NIPPON CHEMI-CON CORPORATION

Engineering Change Notice *Change of plastic reel for SMD type capacitor*

Present reel	New reel
Outside		
Inside

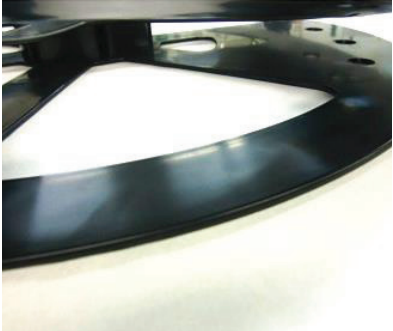
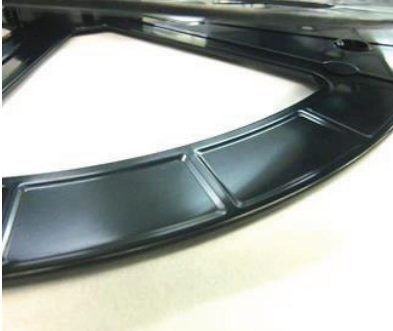
2. Different point of new reel: Only inside design will be changed.

Although the new reels have different inside design as shown in the above pictures, the reel dimensions (JEITA ET-7200C), the material and the strength are the same with those of the present reels.
